Center Hill Dam Consensus Report External Peer Review

August 30, 2007

External Peer Review Panel

Figure 1 Left Rim seepage and sinkhole features and geologic information.
Joint rosette in bottom right.

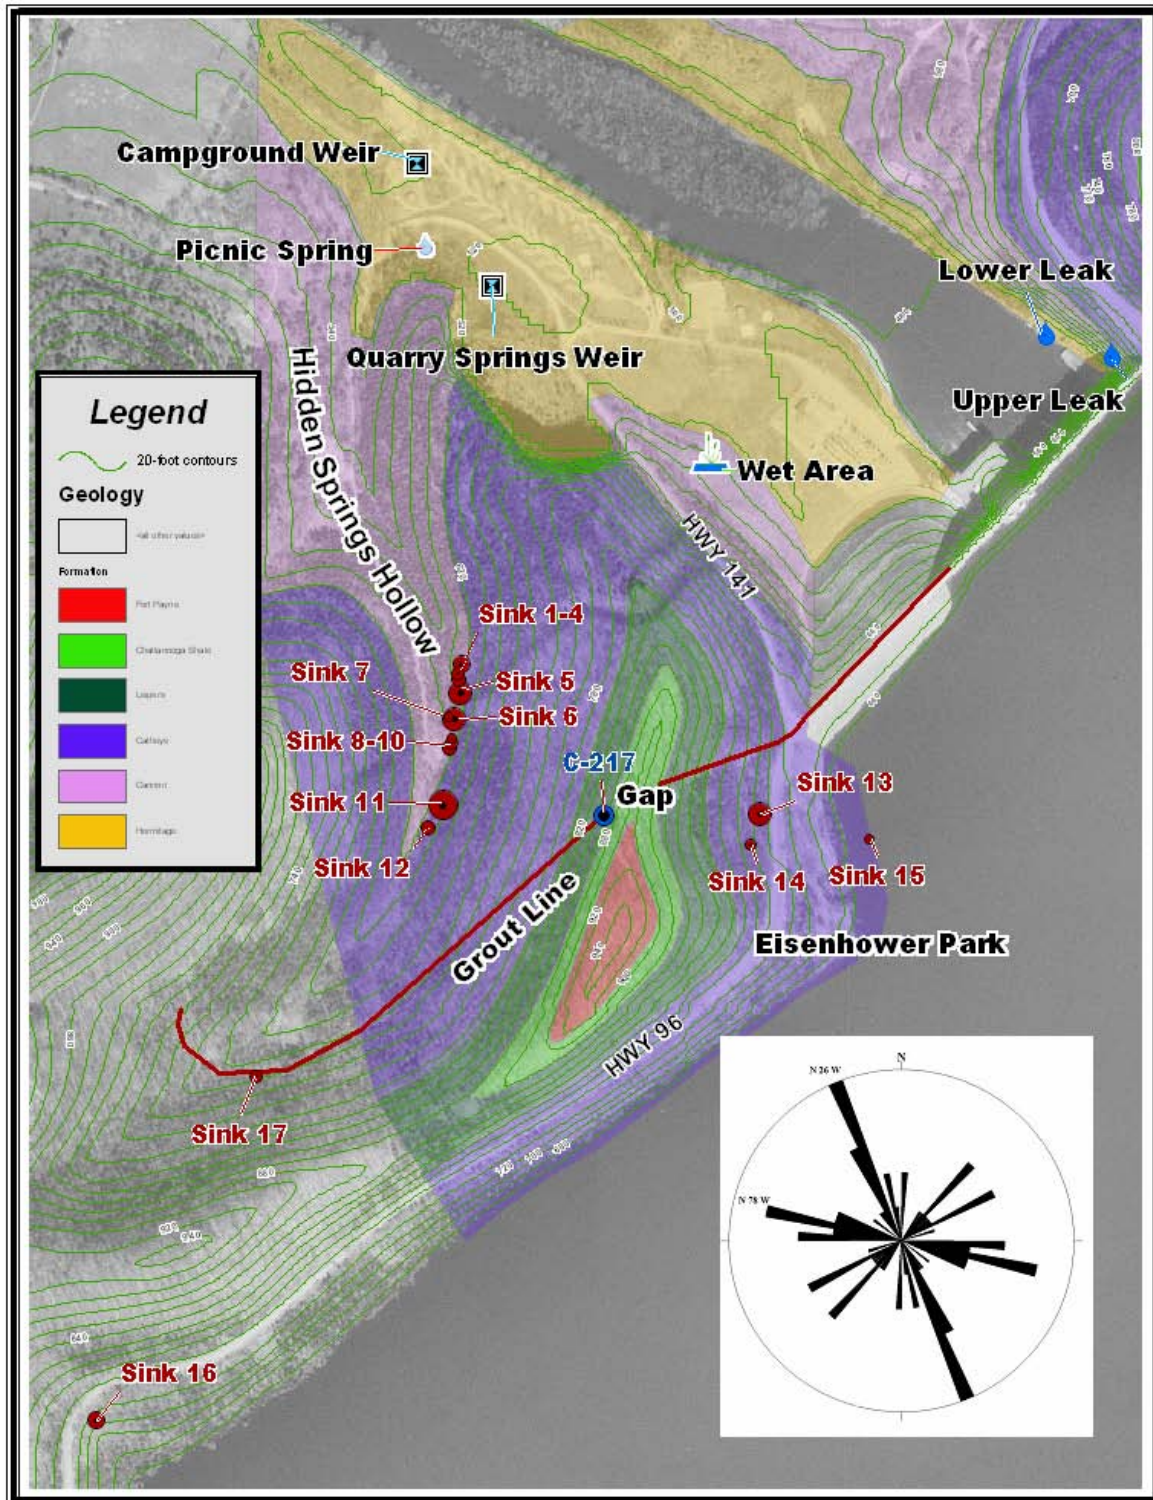
The Panel observed large sinkholes at the surface on the downstream side of the left abutment, apparently along the alignment of cavity features leading from the left rim of the reservoir to the Picnic Spring and/or Quarry Springs area (see photograph No. 5). We also observed a sinkhole in the left bank of the reservoir at the existing lake water surface (elevation 624) (see Photograph No. 6).

The Panel believes that piping of the infilling material in solution features of both abutments was initiated many years ago (likely earlier than 1969 or 1970). The grouting operations in the 1970's and in 1993 served as a temporary deterrent to piping through those areas where the grout curtain was installed; however, piping has resumed since grouting was completed and has continued (perhaps accelerated) in the gap left in the grout curtain on the left abutment. The piping is evidenced by the increasing spring flow and the formation of sinkholes along an alignment from the springs to the reservoir as shown on Figure 1. Figure 1 is the same as Figure 3-27 in the Center Hill Dam MRE Report, which shows the left rim seepage and sinkhole features, geologic information, and the approximate alignment of the grout line with the gap (area not grouted).

The Panel believes that large open flow channels exist in both abutments, progressing from the downstream toward the reservoir. A large breakthrough of one or more flow channels into the reservoir will likely occur in the near future that will release large flows from the reservoir to the downstream channel. Since these flow channels will be restricted to the size of the solution features in the rock, the downstream flooding caused by such a breach would likely be less than the Standard Project Flood. Based upon previous downstream flood routings of this occurrence in either abutment, peak flows would be approximately one-third to one-quarter of the peak flow caused by a collapse of the main embankment or saddle dam. Such a failure would, however, empty the pool causing the loss of the reservoir and its benefits.

Figure 3

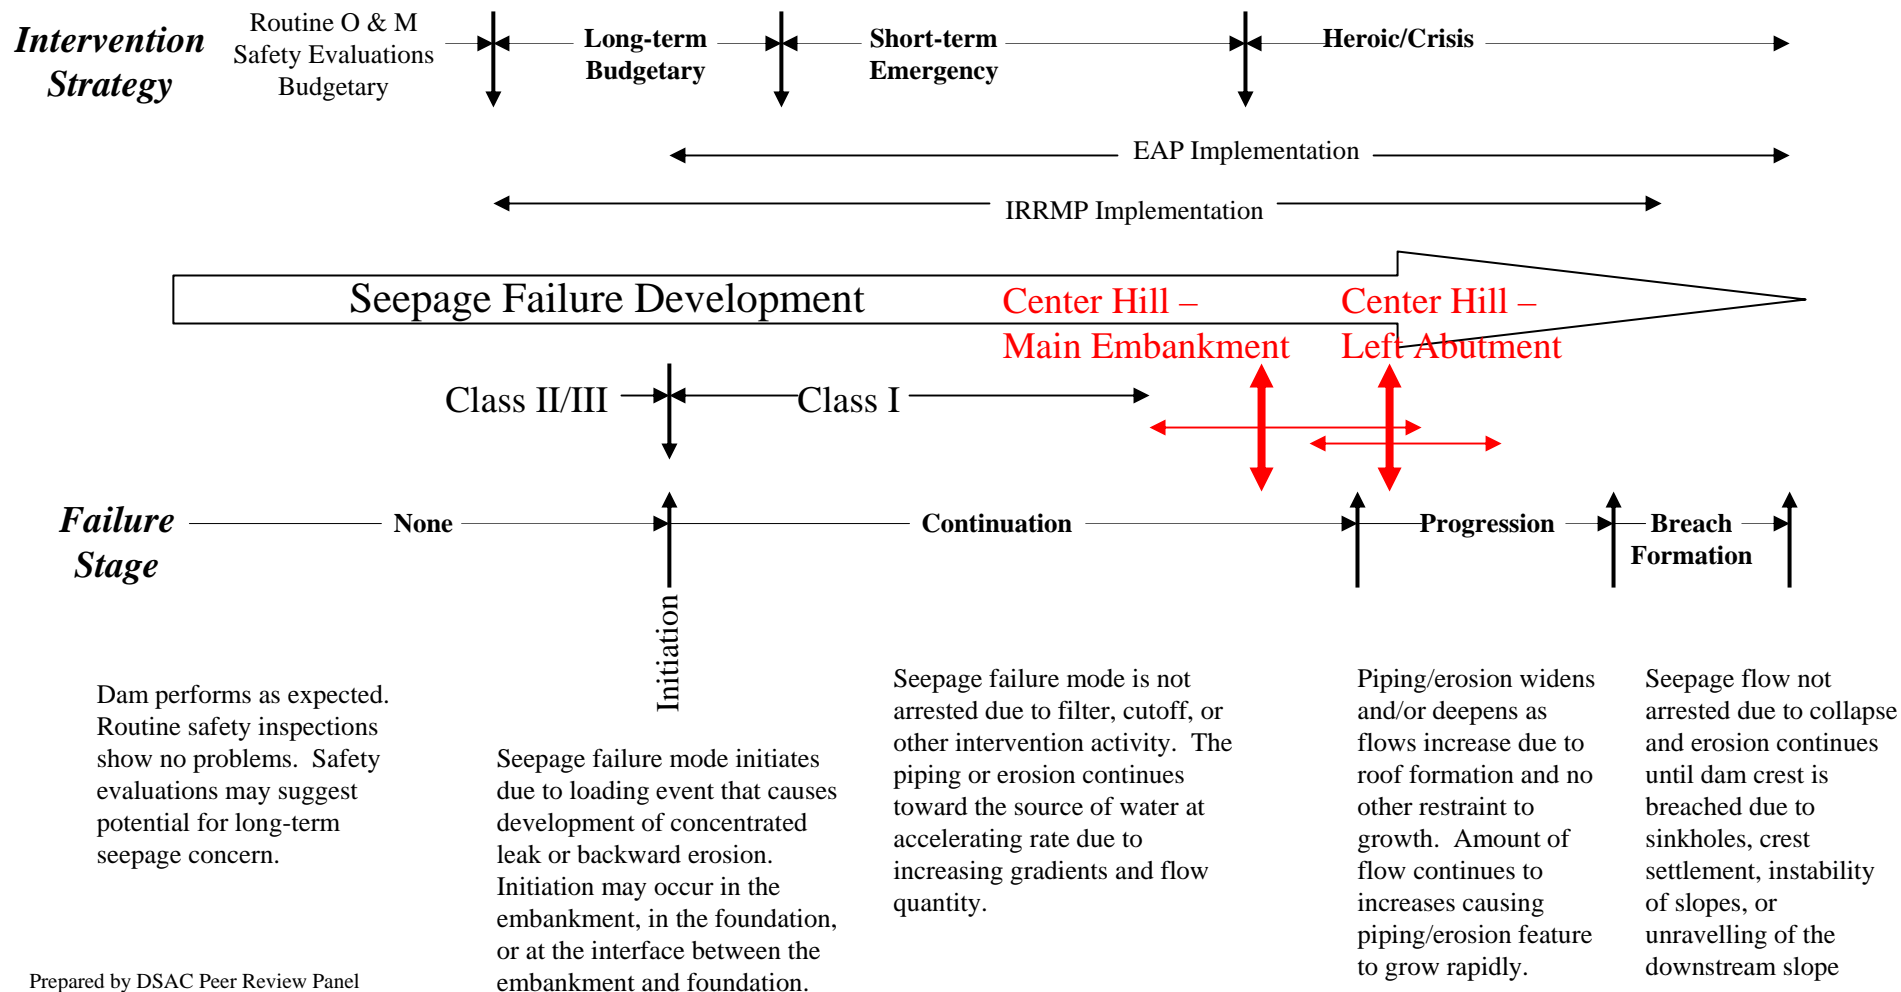
The Panel's estimate of the current condition related to the failure mode continuum for seepage under the embankment section of the Center Hill Dam is shown on the diagram on Figure 3. Figure 3 indicates that a seepage related failure mode has initiated and is in a relatively advanced continuation stage under the main embankment dam. The Panel has made a separate estimate of the current conditions related to the failure mode continuum for seepage failure in the abutments of the dam. The condition for the left abutment is shown on the diagram on Figure 3 and the condition for the right abutment is shown on the diagram on Figure 4. Figures 3 and 4 indicate that a seepage related failure mode has initiated in the abutments, has passed through the continuation phase, and is possibly in the beginnings of the progression phase, but likely more advanced in the left abutment,. If the progression phase has started in the abutments, all that remains is for the erosion to remove additional material from the cavities causing a large break-through into the reservoir in order for failure to occur. The confidence intervals of the Panel's current assessments are also shown on Figures 3 and 4. The Panel believes that the conditions at the site indicate failure of Center Hill Dam could occur under normal pool operation.

In the Panel's opinion, the most advanced piping development and consequently the most likely failure mode is a major breakthrough of the reservoir into a solution feature in one of the abutments. Occurrence of this failure mode would likely drain a significant portion, or perhaps the entire reservoir. However, because of the limiting dimensions of Karst features in the abutments, the downstream consequences of this failure mode development may be less than would occur if the failure was from collapse of the dam. However, the Panel considers there is also a relatively high possibility that failure could occur from continued piping of cavity infilling under the embankment section of the dam sufficient to result in the formation of sinkholes in the upstream slope of the dam similar to the sinkhole development at Clearwater Dam. The reservoir could be released into sinkholes on the upstream slope, causing severe and rapid erosion and collapse of the earth embankment section. This more catastrophic failure is also possible at the saddle dam. Such failures would result in a rapid release of the reservoir and severe flooding downstream resulting in a potential for significant loss of life.

Figure 4

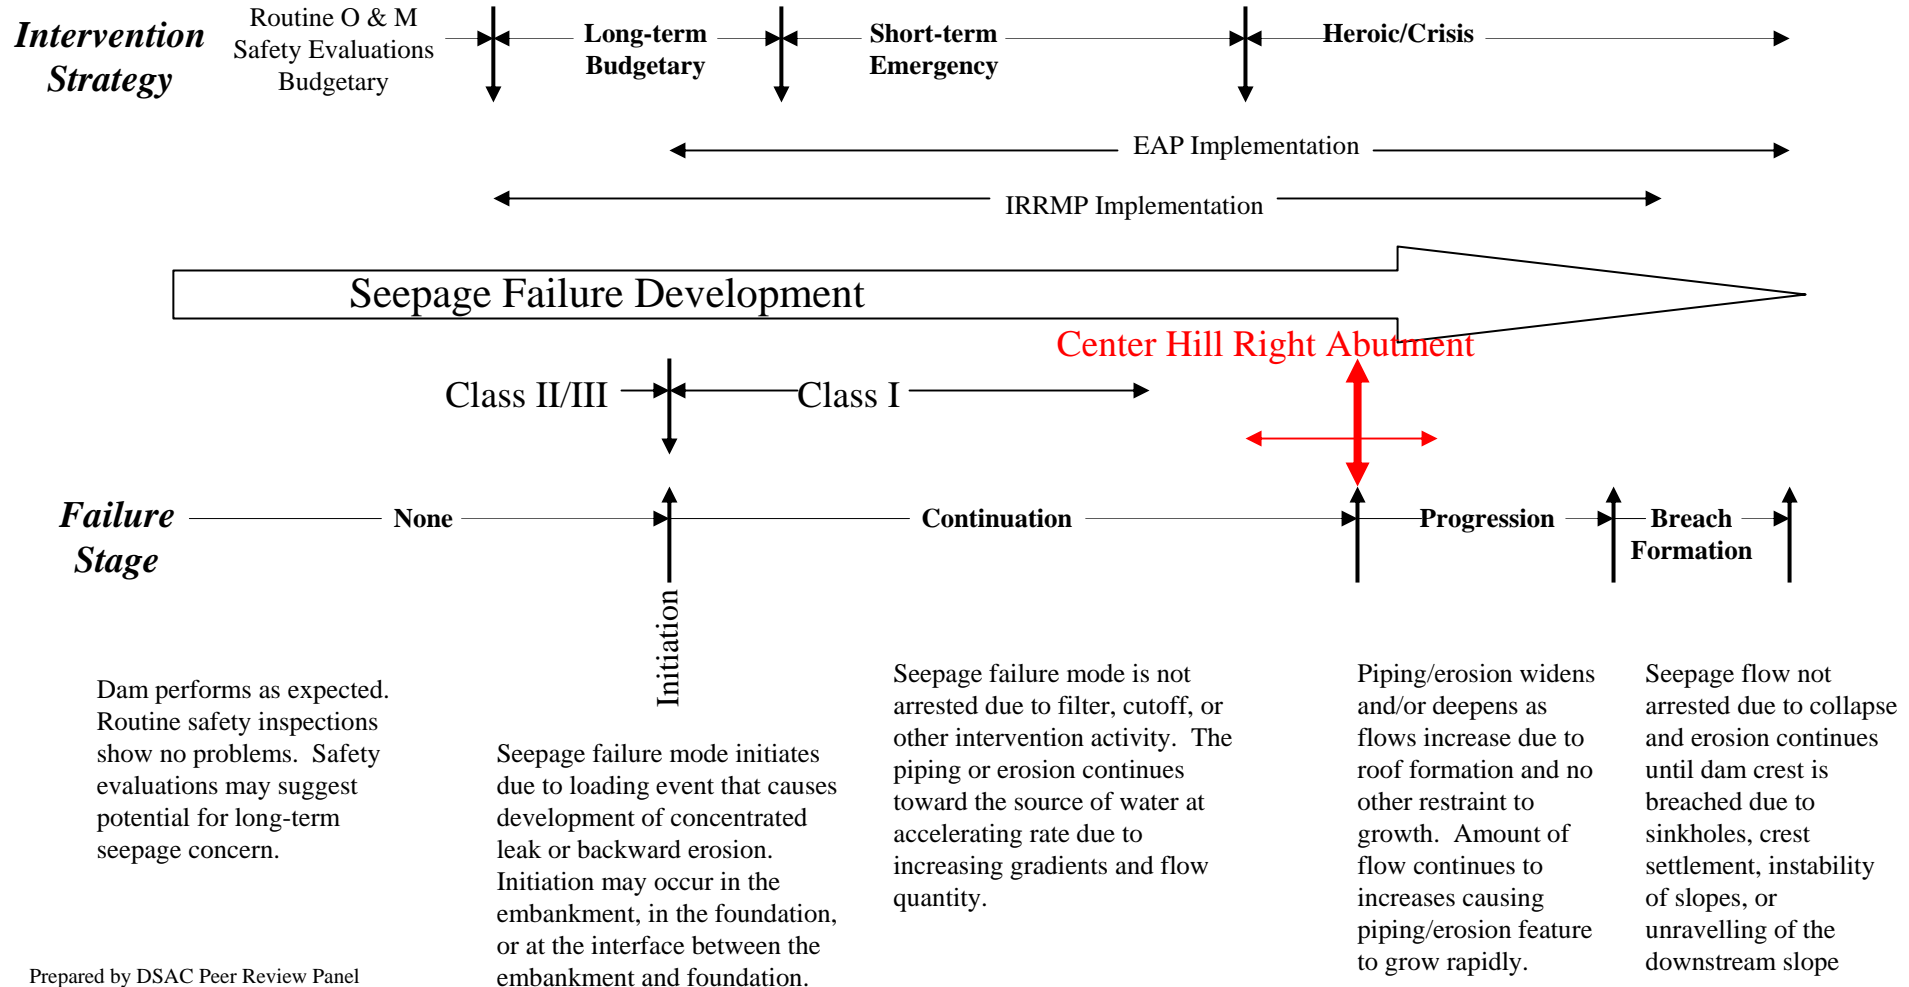
Members of the Panel have been contractually provided a framework to express a dissenting view or views in the form of a “Non-concurrence” report. This report represents a “consensus opinion” of the entire Panel. There are no dissenting views by any member of the Panel. Variations in Panel member opinions are represented by the confidence band presented on Figures 3 and 4.

The Panel notes that the seepage pathways through the right abutment are much shorter than the pathways in the left abutment. When an effective grout curtain is installed in the right abutment, large heads (near reservoir level) will exist on the upstream side of the grout curtain. With the shorter seepage pathways, the gradients will be greater for the right abutment. Consequently, any cutoff should be capable of withstanding the high heads and gradients in order to provide a long term solution. In considering alternatives, a concrete wall may be a more long term solution for the right abutment.
